SAFETY NOTICE

08-597-11

MODELS AFFECTED: HR37/40 Aerials

SUBJECT: *Boom lift cylinder 437250 with s/n codes D or W*

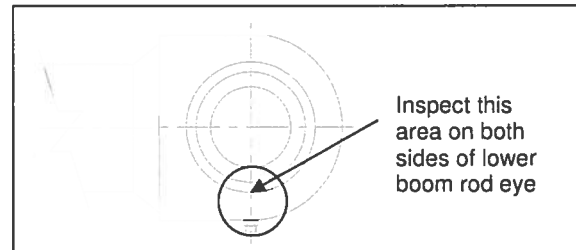
Terex Utilities has determined that some rod eyes on some part number 437250 lower boom lift cylinders are not to specification and can fail. The supplier involved provided cylinders used on HR37M and HR40M units that were built between November 2000 through December 2001 with cylinder serial numbers starting with D or W and followed by 5 or 7 numbers. **If the cylinder rod eye fails the boom and platform may fall.**

Inspect Lift cylinder rod end in this area on both sides. Clean off dirt and grease to see side of rod eye down into the bushing bore.

The owner, or user, must immediately verify if the lower boom lift cylinder on their unit has a serial number starting with D or W by looking on the ID tag near the base end on the cylinder case. If it does not have a serial number starting with D or W, the unit is not involved with this Safety Notice. If it does have a serial number beginning with D or W, perform a visual inspection of the cylinder rod eye in the area of the grease zerk (see figure below). Clean off the dirt and grease to determine if a crack is evident near the ball bushing. If there is any indication of a crack immediately remove the unit from service and contact Terex Utilities at 605-884-3892. If no crack is detected arrange a hardness test inspection to verify the material by calling 605-884-3892, or sending a fax to 605-882-5572, or sending an email with the machine information to utilities.warranty@terex.com or by contacting the nearest Terex Utilities dealer within 45 days. You may continue to use the unit if you inspect the rod eye daily and verify that no cracks are present.

Affected units, as shown on the owner letter, of part number 437250 and the date codes D or W will have the cylinder rod inspected at no charge to the owner. If the material is not to specification the cylinder rod will be replaced at no charge to the owner.
